Dr. Linda Little
ASLB TMI #1 RESTART
UBNRC
DEAR ALW Little,

TEST BORING H³ CONCENTRATIONS

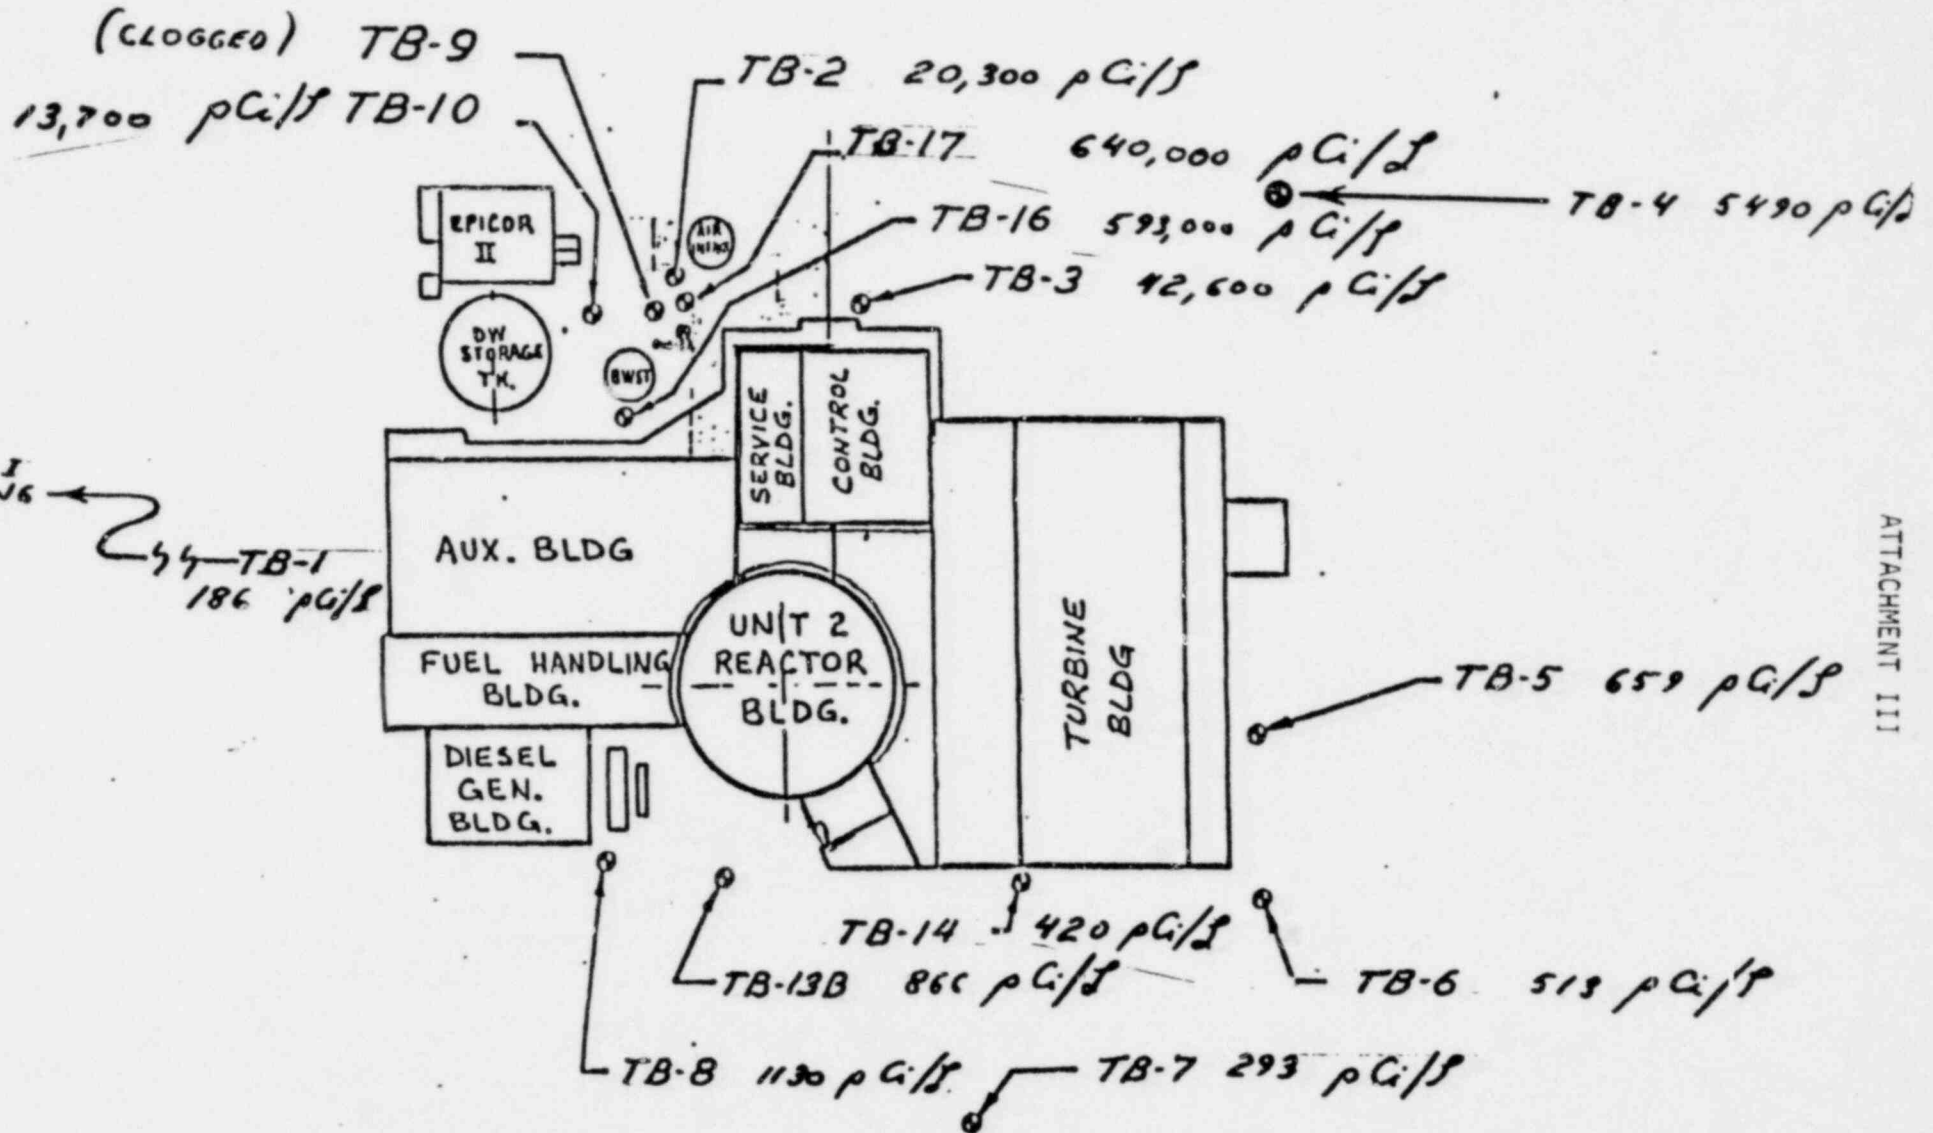
You asked a question about TRITIUM CONTAMINATION
IN TEST WELLS. I AM ENCLOSING A MAP
SHOWING STRONG H^3 CONTAMINATION. THIS HAS
INCREASED REGULARLY.

HAVE YOU SEEN THIS MAP AND DO YOU
CONSIDER THIS CONTAMINATION ABLE TO
AFFECT THE SAFE OPERATION OF UNIT #1?
NO ONE HAS GIVEN AN ESTIMATE OF THE
TOTAL H^3 CONTAMINATION AS YET, NOR OF
THE SOURCE OF THE CONTAMINATION. THERE
HAS BEEN SPECULATIVE STATEMENTS, BUT
NO REAL PROOF.
